First Revision No. 8210-NFPA 70-2024 [Global Input]

Revise the following sections of Article 210 and Annex D, as shown, to align the terminology used for overcurrent protection:

Figure 210.52(C)(1) Determination of Area Behind a Range, Counter-Mounted Cooking Unit, or Sink.

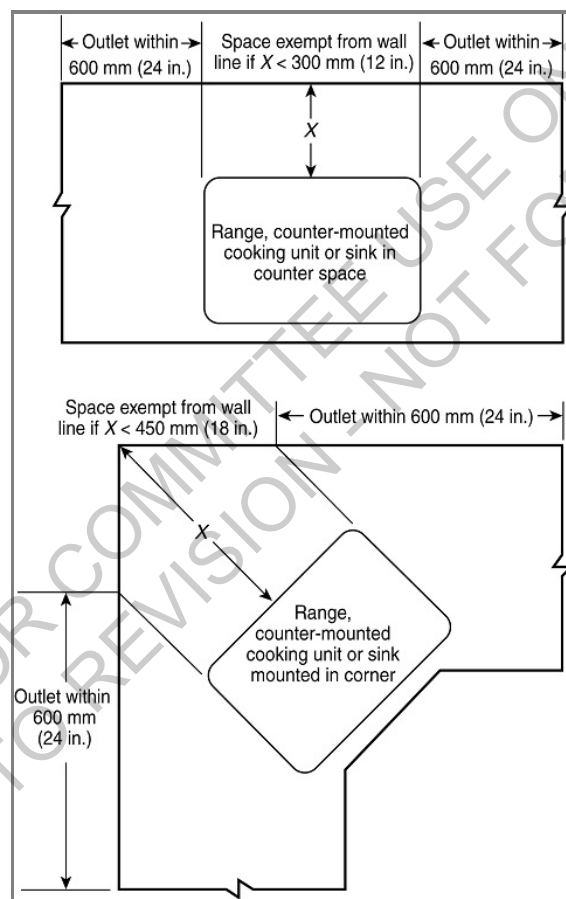
Exception No. 1: Receptacle outlets shall not be required directly behind a range, counter-mounted cooking unit, or sink in the installation described in Figure 210.52(C)(1).

Exception No. 2: Where a required receptacle outlet cannot be installed in the wall areas shown in Figure 210.52(C)(1), the receptacle outlet shall be permitted to be installed as close as practicable to the countertop area to be served. The total number of receptacle outlets serving the countertop shall not be less than the number needed to satisfy 210.52(C)(1). These outlets shall be located in accordance with 210.52(C)(3).

Committee Statement: CMP 2 reaffirms receptacle outlets are not required to be installed at island and peninsular countertops and work surfaces. Such locations may be designed where the requirements in 210.52(C)(3) and (4) cannot be met. The requirement for "future provisions" is also retained as certain construction methods may not allow receptacle outlet that meet the requirements of 210.52(C)(3) and (4) to be added at a later date. 210.52(C)(4) has been added to clarify as to where receptacle outlets can and cannot be installed, at new construction or a future date.

Figure D14(a) Monitoring Controlled and Non-Controlled Loads, 50 A EVSE.

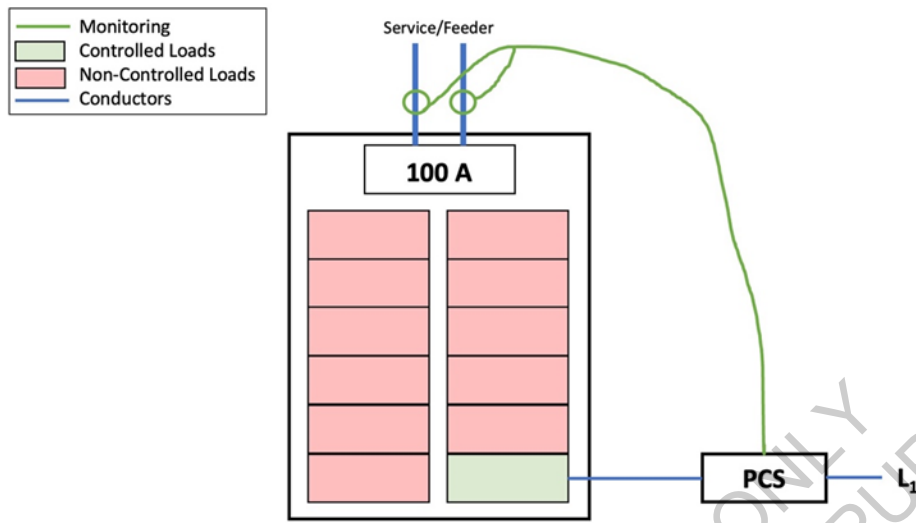
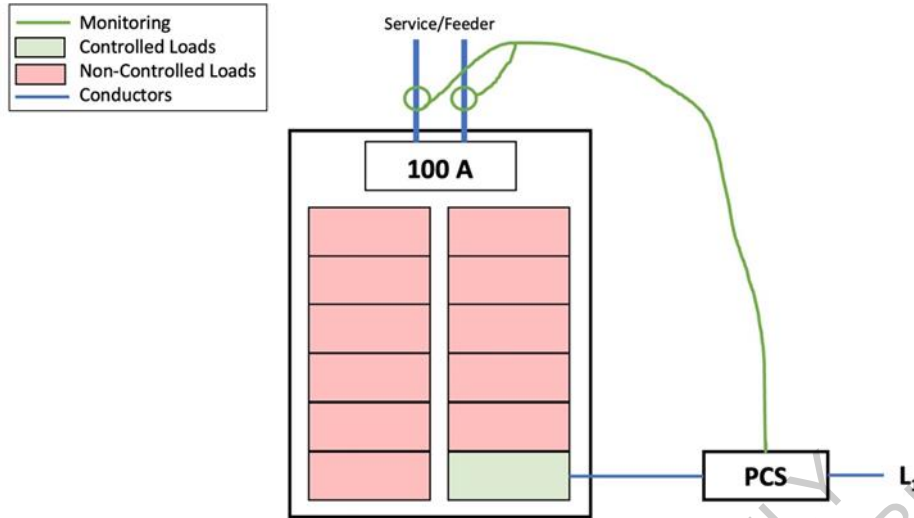
Total service load is non-controlled plus controlled loads = 17,040 volt-amperes (71 A, 240-V).

See Figure D14(a).

Committee Statement: Four examples are added to Annex D to aid in the application of the requirements related to Power Control Systems (PCS) included in the Section 220.7 (formerly 220.70). As a new provision in the Code, with multiple options, these examples are intended to ensure clear understanding of the requirement.

Figure D14(b) Monitoring Controlled and Non-Controlled Loads, 30 A EVSE.

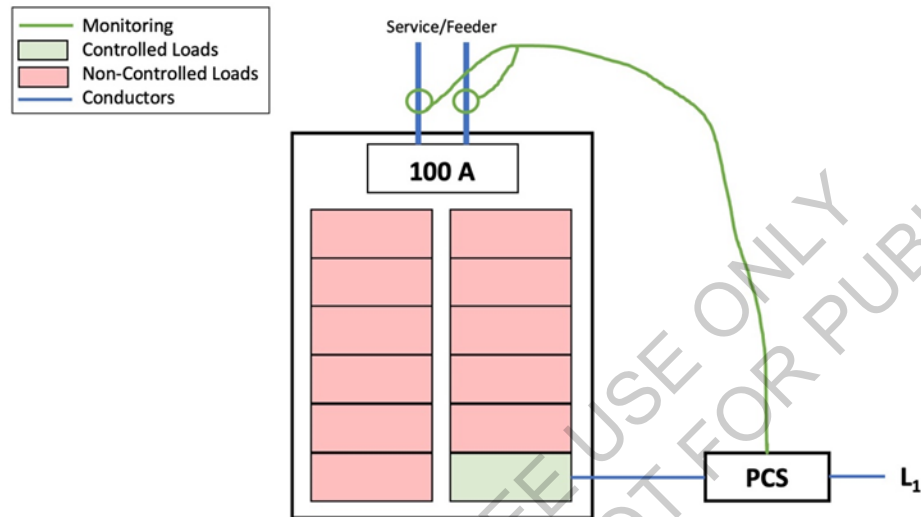
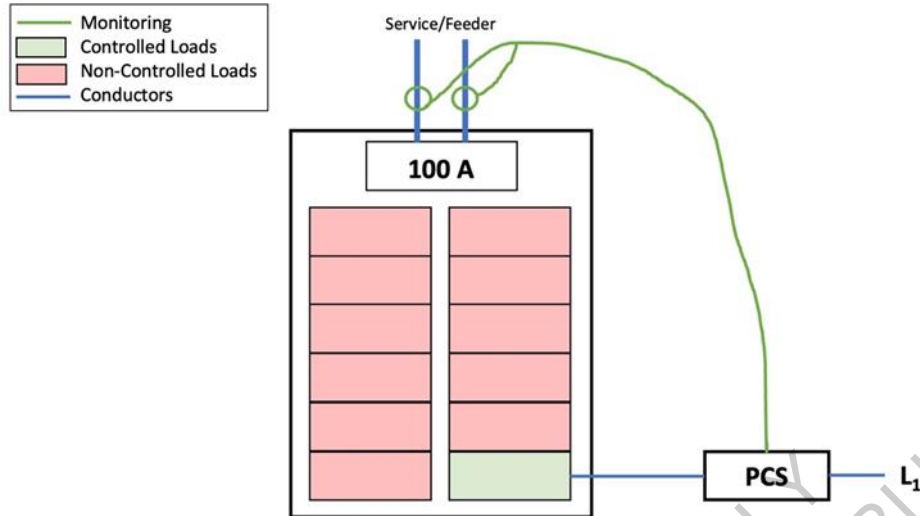
Total service load is non-controlled plus controlled loads = 23,760 volt-amperes (99 A, 240-V).

See Figure D14(b).

Figure D14(c) Monitoring Only Controlled Loads, 35 A EVSE, 20 A Pool Pump, and 30 A HVAC Heat Pump.

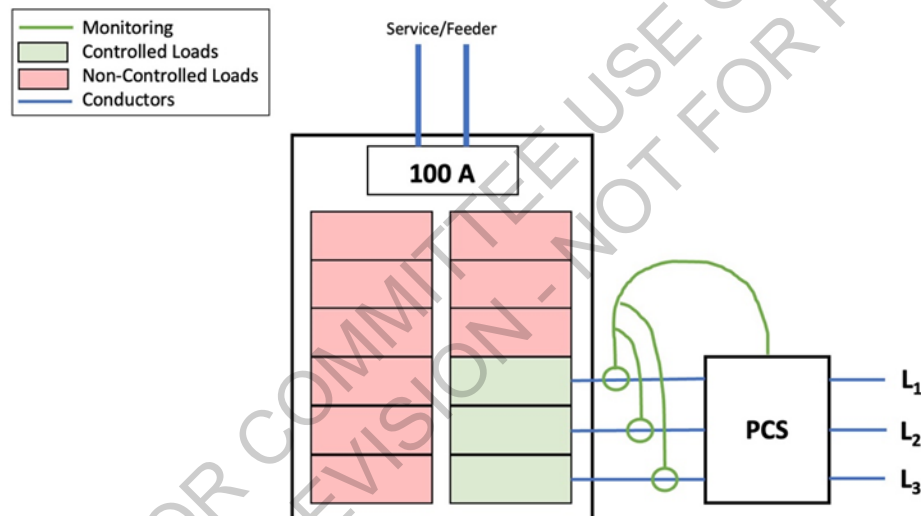
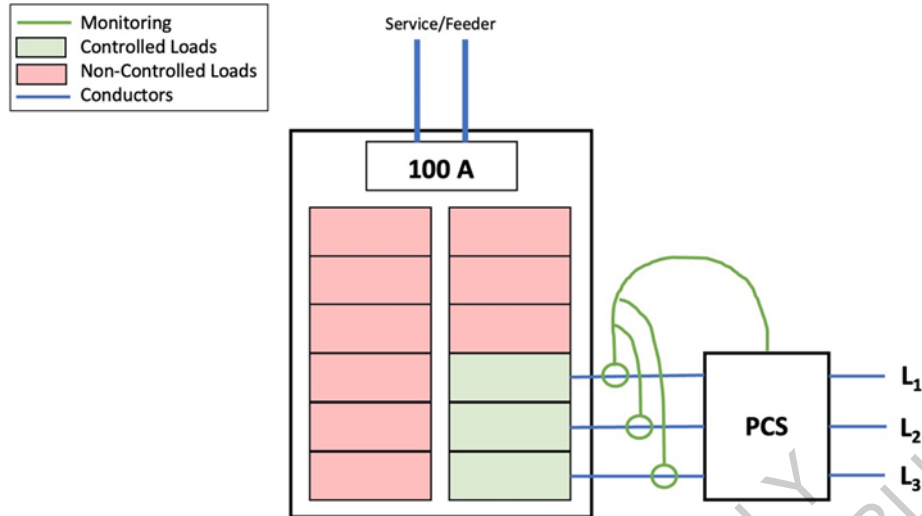
Total service load is non-controlled plus controlled loads = 23,040 volt-amperes (96 A, 240-V).

See Figure D14(c).

Figure D14(d) Monitoring Only Controlled Loads, All Loads Controlled.

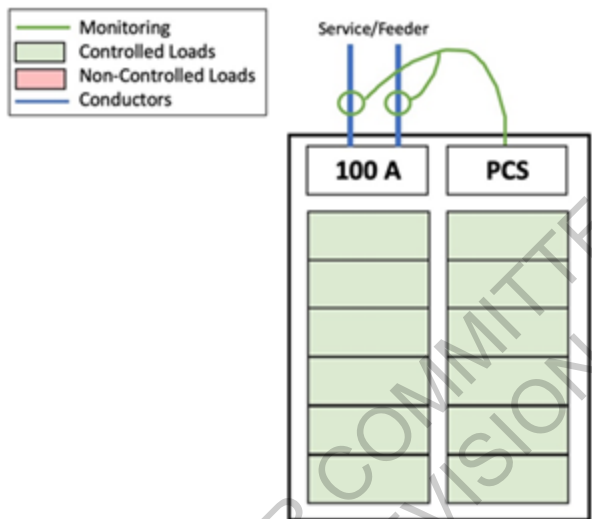
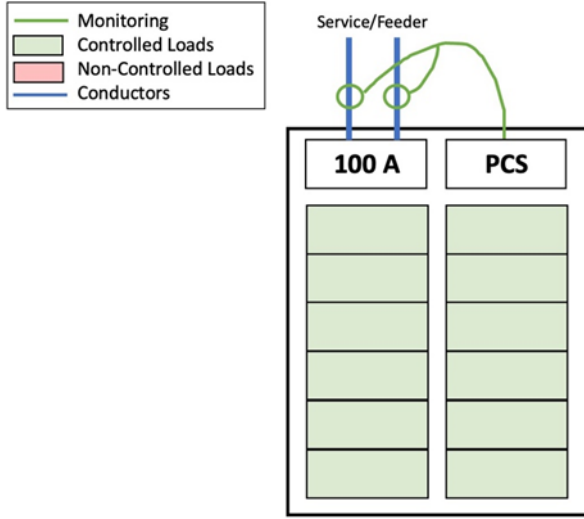
Total service load is non-controlled plus controlled loads = 19,200 volt-amperes (80 A, 240-V).

See Figure D14(d).
